June 6, 2024

To Eversource permitting,

I repeat my May 30 request: Explain why the portion of the X-178 proposed complete line rebuild covered by this AoT application, 'Easton non-WMNF,' is stated to be "within a public right-of-way."

# Canada Lynx Protection Zone for Trapping Restrictions

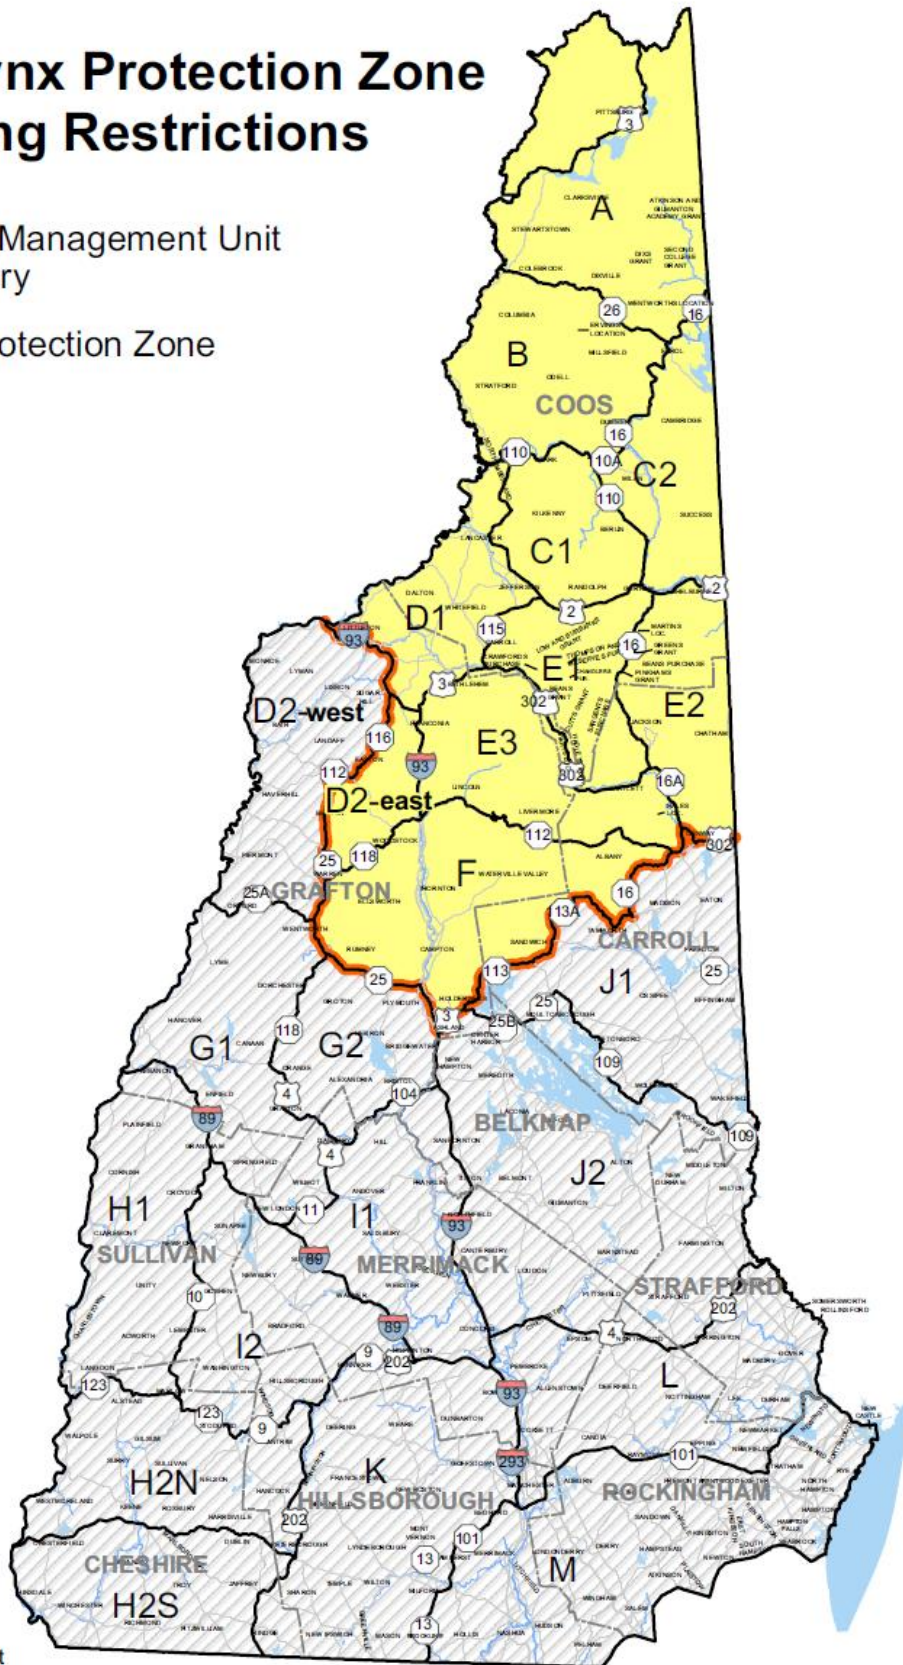
#7. The AoT applications states that there is no critical lynx habitat around the X-178, yet the N.H. Canada Lynx Protection Zone for Trapping includes the area west of Route 116. Will the information above be in the AoT for the X-178-2 which covers the easement within White Mountain National Forest?

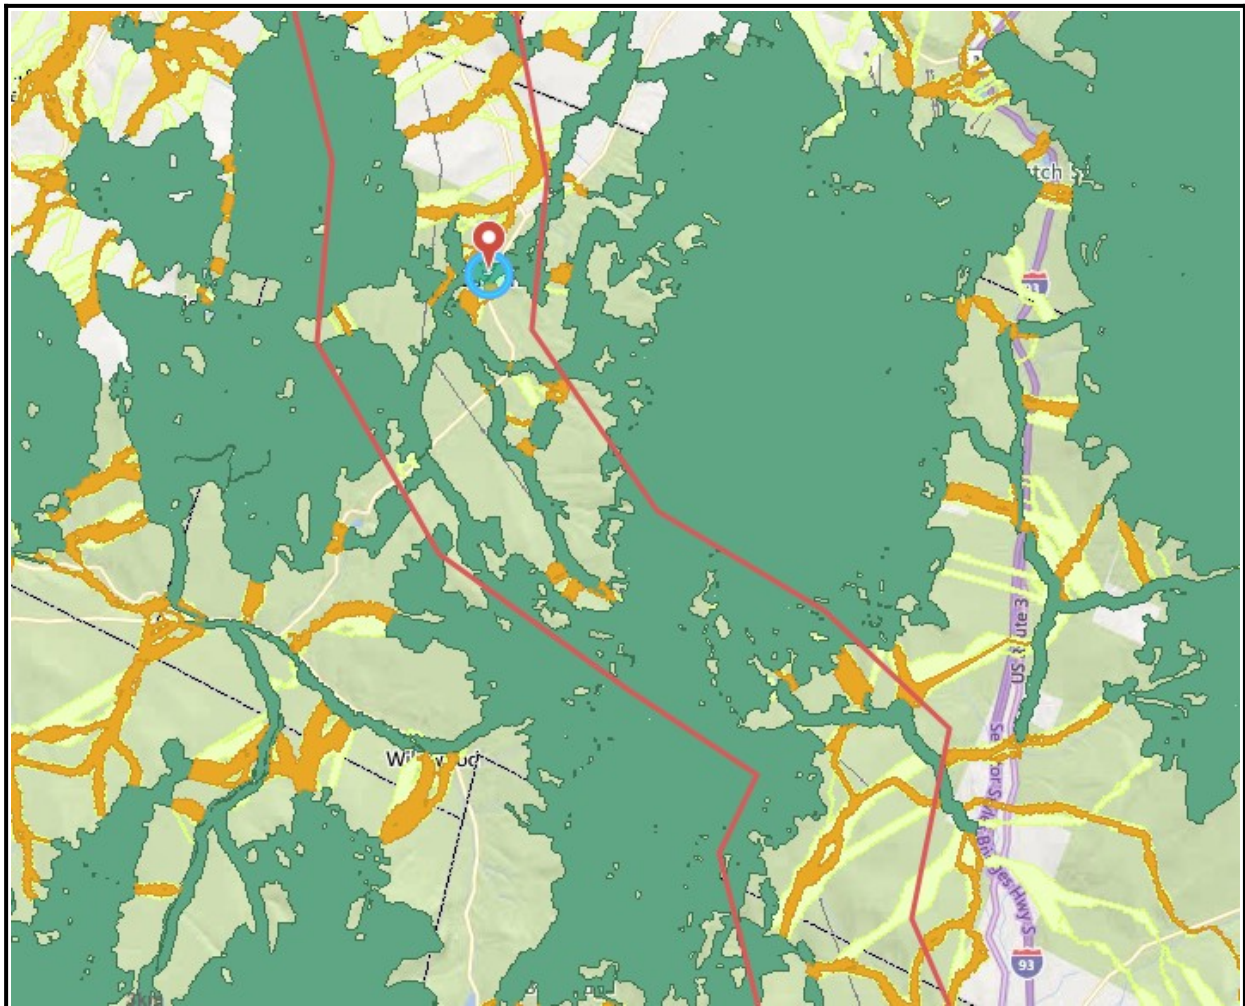
**#8.** Below: The X-178 in part of Sugar Hill, Easton, and part of North Woodstock. Orange indicates wildlife corridors and green indicates prioritized habitat. The corridors connect the habitat areas and continue through them. The X-178 has been degrading important wildlife corridors and habitat since 1948. It would not be permitted to be built now. The proposed rebuild, with 39 acres of permanent degradation of built roads and construction areas, and construction, with months of noise and pollution, will certainly drive many animals and humans out of a large area: Sound moves and reverberates for long distances in the Easton valley. The noise of a illegally mufflered motorcycle can travel more than a mile, so Eversource's proposed months of heavy construction will have extensive and long term, if not permanent, effects on humans and wildlife. With audible construction noise comes infrasound, an additional physical and psychological stressor about which Eversource is also silent.

The red lines show a crude noise pollution zone for the X-178, with one mile travel for noise shown on either side of the line. The cleared easement would be a travel corridor for noise, so noise pollution within the cleared easement would be intense.

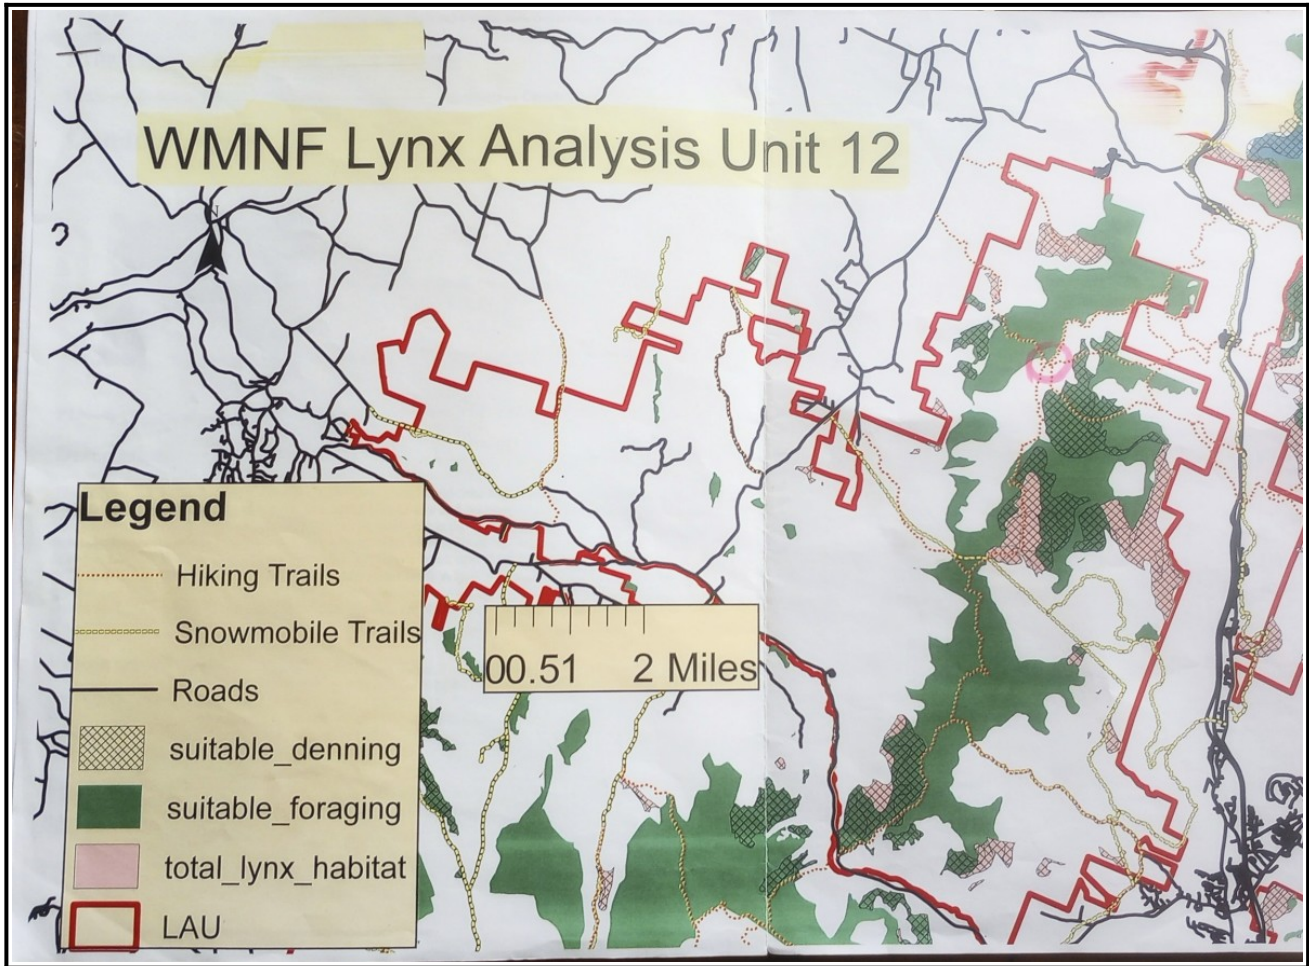
**#12.** Drill spoils may be contaminated with creosote, pentachlorophenol and other chemicals that have migrated from the existing poles, and should be disposed of in an appropriate landfill, not “non-jurisdictional areas” on the easements.

All wood pole butts must be removed, since they are heavily saturated with pentachlorophenol, creosote, fuel oil and other treatments for slowing decay.

Eversource has provided no documentation showing that removing these poles is more damaging to wetlands than leaving them to continue to contaminate wetlands.
